MILITARY SPECIFICATION

INTEGRATED CIRCUIT, DIGITAL, CMOS LOGIC ARRAY MONOLITHIC SILICON

This Amendment forms a part of Military Specification MIL-I-48634 (AR), dated 31 July 1986, and is approved for use by the U.S. Army Armament Munitions and Chemical Command, and is available for use by all Departments and Agencies of the Department of Defense.

FIGURE 3. LEAKAGE CURRENT TEST.

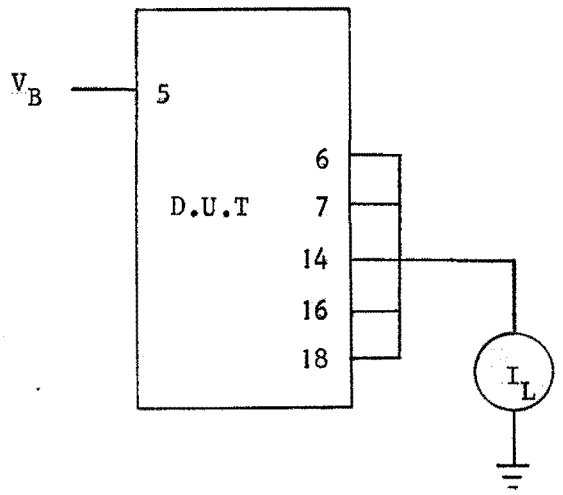
Add the following figure:
